**Declaration for the Decision Document
Dura Avenue Landfill Site
Toledo, Ohio**

INTRODUCTION TO RESPONSIVENESS SUMMARY FOR COMMENTS RECEIVED ON THE PREFERRED PLAN OF 1999.

INTRODUCTION TO RESPONSIVENESS SUMMARY FOR COMMENTS RECEIVED ON THE PREFERRED PLAN OF 1995

FIGURE 1. ARSENIC VS. ALUMINUM CONTENTS FOR Dura Avenue Landfill LEACHATE SAMPLES, LOWER CONCENTRATION RANGE.

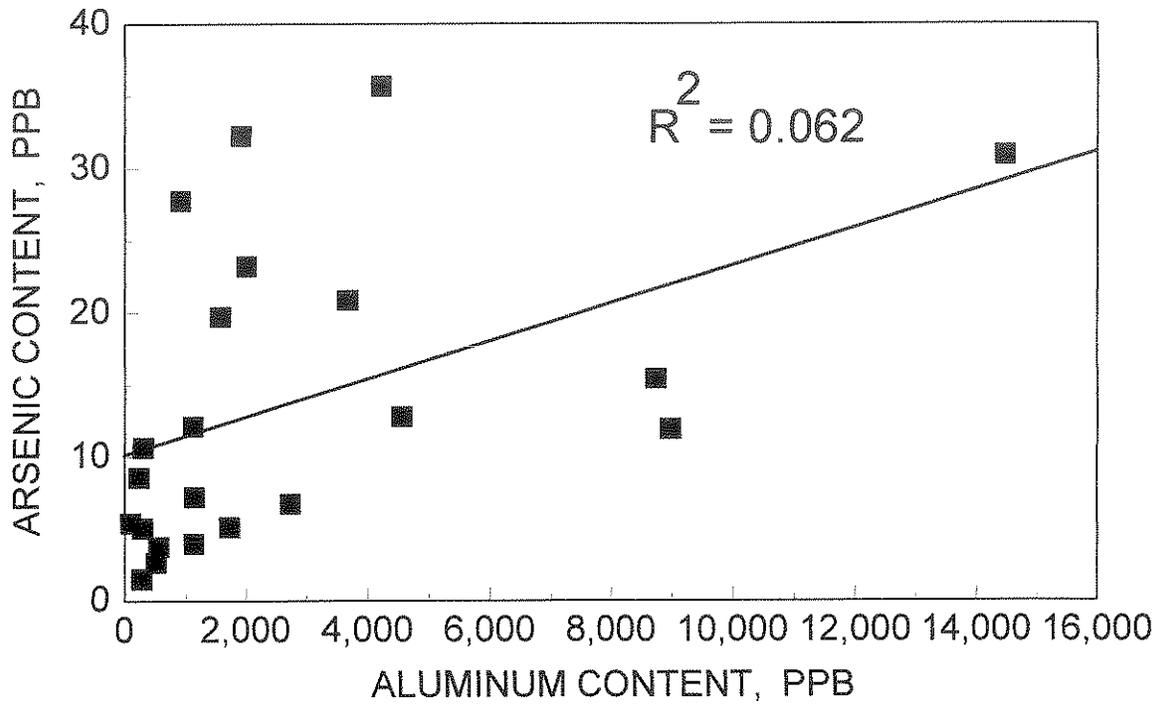
The comments assert that the arsenic detected in the leachate samples is really a false-positive signal resulting from the presence of massive quantities of aluminum. While aluminum may present spectral interference which could be misinterpreted as arsenic (caused by a minor spectral peak from aluminum which is similar to a major peak of arsenic), the statistical analysis presented by the commentator fails to prove that such has actually occurred in these analyses. The comments include plots of aluminum and arsenic concentrations in the leachate specimens, which purport to show a linear relationship between the two, and would be consistent with a minor spectral peak of aluminum being interpreted as a spectral peak of arsenic. A careful examination of these analyses and a reexamination of the original data show that the commentator's analysis contains an inaccurate and inappropriate use of statistical regression

A more accurate analysis of these data points is presented in the plots below. Figure 1 contains the lower range data points (aluminum less than 15,000 ppb). This plot shows a very low degree of correlation between the aluminum and arsenic levels. Indeed, a regression analysis shows a correlation coefficient, R , for these data of approximately 0.28 ($R^2 = 0.082$), which is below the level for statistical significance. At best these data indicate that the arsenic and aluminum levels generally increase together, as would be expected if they came from the same source waste stream. However, the claim that the arsenic signals result from a systematic misinterpretation of aluminum spectral emissions cannot be supported from these data. Such a conclusion would require a highly linear relationship between the two, which is not demonstrated here.
